**Flood Control Project Maintenance
Levee Inspections**

Maintenance Issue Types Only, Levee Inspection Report By Mile - Spring 2017

Butte County Department of Public Works

Waterway	Bank	Unit Miles	Inspection Start/End	Inspector
Unit No. 01 Mud Creek	Right	6.80	04/20/2017 04/20/2017	Bob Duffey

Photo 2 of 2 : UCIP_SP_2017_30388_55890.jpg

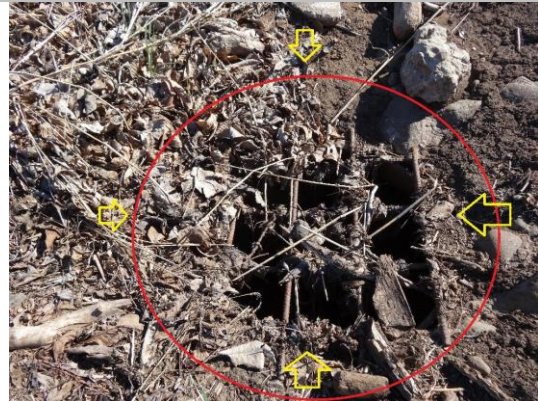
Comment Code						
Inspector Comment						
FS_ID:30388 DS_ID:19221 EP_NO: N/A Repair Type: Non-Urgent Crossing Status: Found UCIP Comments: CM Standpipe intake. Intake pipe with air vent. Steel rib-bar grit cover on the standpipe on landside levee toe.Needs cleaning and clearing on both ends of the pipe. FIELD_STRUCT_DESC: 24-inch CM pipe through the levee, 15.0 feet below the crown. Flap gate on the waterward end. Concrete "U" headwalls on waterside ends. Grouted riprap spillway on the waterward end. CM Standpipe intake. Intake pipe with air vent. Steel rib-bar grit cover on the standpipe on landside levee toe. O&M Manual Sac 504, May 1965. FS Date: 2/20/2014

Photo 1 of 2 : UCIP_SP_2017_31129_57036.jpg

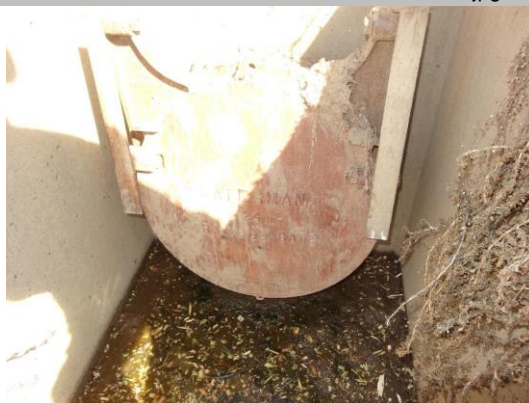
LM Start	7.77	Rating **	M	Issue No.	59
LM End	7.77	Issue Type +	Ma	Location *	LS
Category	Supplemental			GPS Latitude/Longitude	
				Start	End
Item	DWR UCIP LMA Responsibility			39.711436 °	39.711436 °
				-121.937135 °	-121.937135 °
DWR ID					
Comment Code					
Inspector Comment					
FS_ID:31129					
DS_ID:19254					
EP_NO: N/A					
Repair Type: Non-Urgent					
Crossing Status: Found					
UCIP Comments: Debris in inlet pipe, needs cleaning and clearing.					
FIELD_STRUCT_DESC: 24-inch CM pipe through the levee, 18.0 feet below the crown. Flap gate on the waterward end. Concrete "U" headwalls on both ends. Grouted riprap apron on the landward end. Grouted riprap spillway on the waterward end. O&M Manual Sac 504, May 1965.					
FS Date: 2/25/2014

WS view: U type concrete headwall, pipe, and flapgate on levee slope.
Soil/mud on outlet box.

Photo 1 of 2 : SP_2017_NA0003_69_3_20170426_00010.jpg

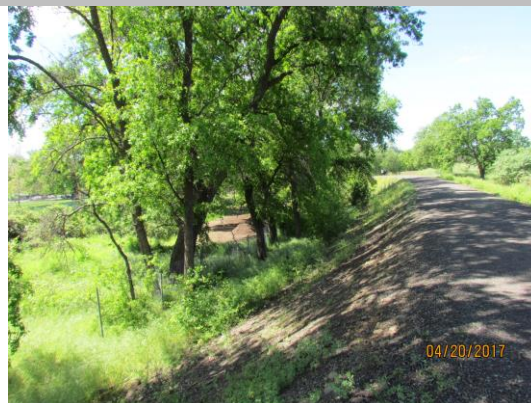
LM Start	0.34	Rating **	M	Issue No.	3
LM End	0.42	Issue Type +	Ma	Location *	LS
Category	Earthen Levee			GPS Latitude/Longitude	
				Start	End
Item	Vegetation			39.761633 °	39.761117 °
				-121.795155 °	-121.796464 °
DWR ID	DWR_NA0003_05_f_2013_3				
Comment Code					
V2 : Remove the wild growth other than native grasses from the levee slopes.					
Inspector Comment

View of the vegetation along the landside slope and toe.

Photo 1 of 1 : SP_2017_NA0003_69_14_20170426_00013.jpg

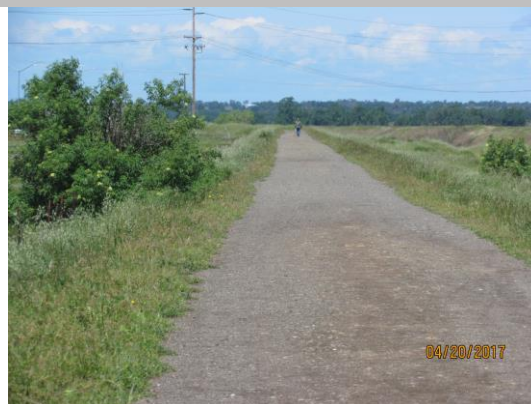
LM Start	0.84	Rating **	A	Issue No.	14
LM End	0.84	Issue Type +	Ma	Location *	LS
Category	Earthen Levee			GPS Latitude/Longitude	
				Start	End
Item	Vegetation			39.763700 °	39.763700 °
				-121.802752 °	-121.802752 °
DWR ID	DWR_NA0003_05_s_2017_14				
Comment Code					
V1 : Control annual grass and weeds on the levee slopes and easements.					
Inspector Comment

View of the native grasses on both slopes.
